## MOTORCYCLE BRAKES GTR.

**PROPOSAL FOR NEXT VERSION BY INCLUDING COMMENTS RECEIVED ETC.**  
**Dated Sept. 30th**  
**FOR DISCUSSION AT 5/MCGTR INFORMAL MEETING**

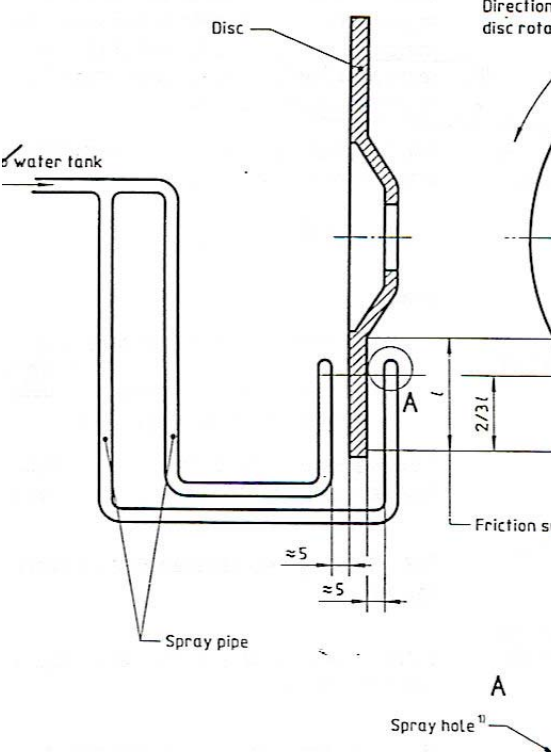
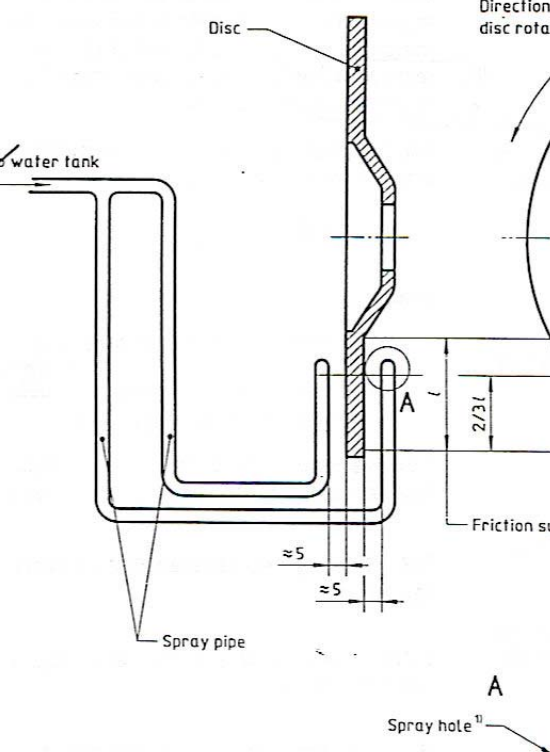
All fractions to be changed to decimals.

The requirements for category 3-4 should be equal to those for category 3-5.

(Delete the note.)  
Note:
